Sunfield Fast-track

Auckland Council Specialist Memo

Parks Planning Memo

Date: 4 August 2025

Figure 5 Proposed gas line to traverse the site in relation to the open space network.

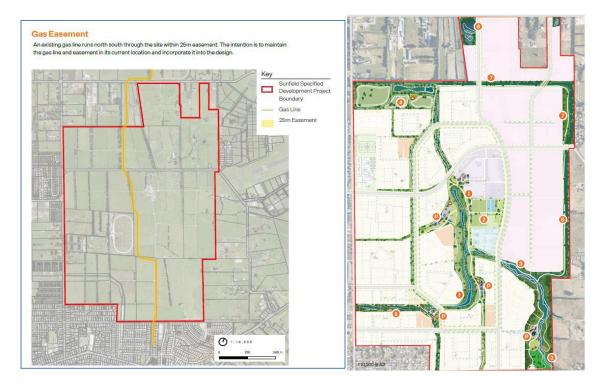
3.24. The 25-metre-wide gas pipeline designation further constrains an already burdened central open space corridor by precluding the placement of key formal recreation assets, but further now requires third-party approval on council-owned land should the council consider developing assets further. Its integration within the drainage reserve network may reduce land use conflicts with development but results in a spatial outcome that significantly limits the ability to deliver functional, active recreation within the core of the open space network.

Figure 6 Examples of green pockets and commonly owned access lots throughout the scheme plan prepared by Maven, Revision A, DWG SL4-C150-0 and DWG SL3-C150-0

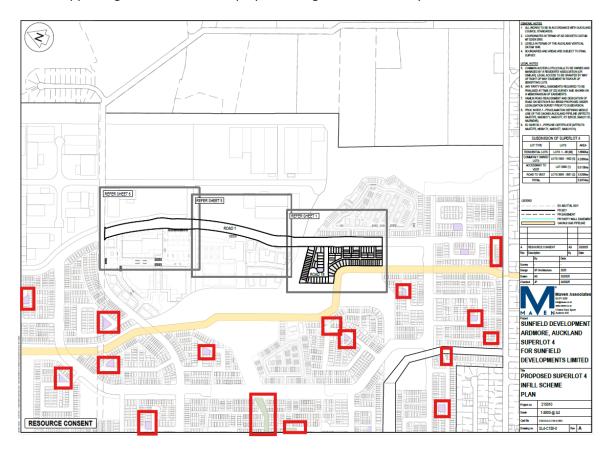
3.28. In summary, these privately managed green spaces, while complementary in some respects, cannot substitute for the provision of publicly owned neighbourhood parks capable of supporting formal recreation, play, and long-term community use.
